## CAIRNGORMS NATIONAL PARK AUTHORITY

**Title: REPORT ON CALLED-IN PLANNING APPLICATION**

**DEVELOPMENT PROPOSED: APPROVAL OF RESERVED MATTERS FOR MASTERPLAN FOR CONSTRUCTION OF 75 HOUSES AND ASSOCIATED ROADS, ENGINEERING WORKS, SERVICES AND AMENITY GROUND AT Highburnside, AVIEMORE, PH22 1QD.**

**REFERENCE: 05/177/CP**

Fig. 7 : Extract from overall site layout plan, showing Zones 1 (plots 9 - 26); 2 (plots 1 - 4 and plots 5 - 8).

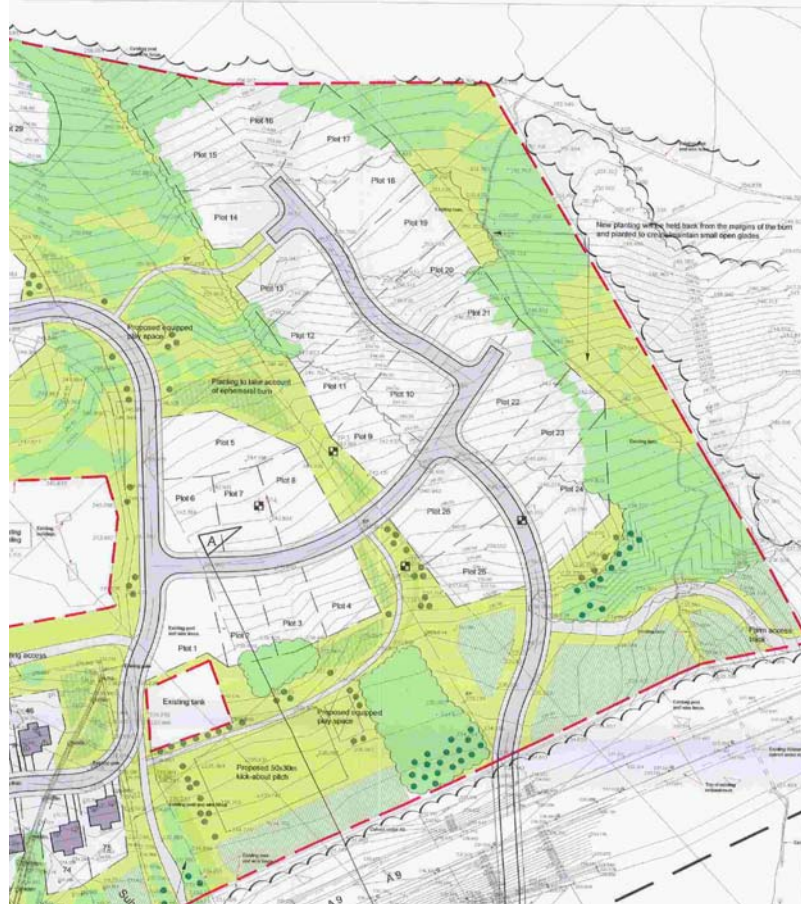
10. The dispersal of the 75 house plots into a number of zones within the site has resulted in a layout that attempts to concentrate a significant proportion of future properties within existing open areas or relatively sparsely vegetated areas of the site. In an effort to highlight this, the application documentation includes an aerial photograph of the site area overlain with the proposed layout. Approximately 40% of zone 1, all of zones 2 and 3 and significant tracts of zone 4, are according to the 'aerial photo overlay' proposed largely on grazing ground. On the other hand, the same overlay clearly shows that at least 37 of the 75 plots proposed would result in the need for the felling of existing vegetation, with the areas most likely to be affected located in the south east (in zones 5 and 6) as well as several plots to the north and west (zone 1) and pockets of plots on the higher ground to the south west (zone 4).

49. The central area of the site (plots 1- 8) is detailed as largely occupying grazing land, resulting in the loss of a limited amount of trees and consequently the ecological impact on this zone is considered to be relatively slight. Some concern is raised regarding the route of the proposed access road through this area, where there is potential for the loss of some trees, particularly aspen, and it is suggested that the proposed road follows the route of the current track more closely in order to minimise destruction of the trees, and that the aspen trees are safeguarded during and after construction.

50. The final stage of the **NHG** assessment focuses on the northern area of the site (in the vicinity of plots 9 – 26), and the area is described as being a mosaic of birch woodland and grassland, and noting that the proposed development would result in the loss of a considerable amount of birch woodland in this area, resulting in the greatest clearance of woodland in area of the distinct housing areas proposed.
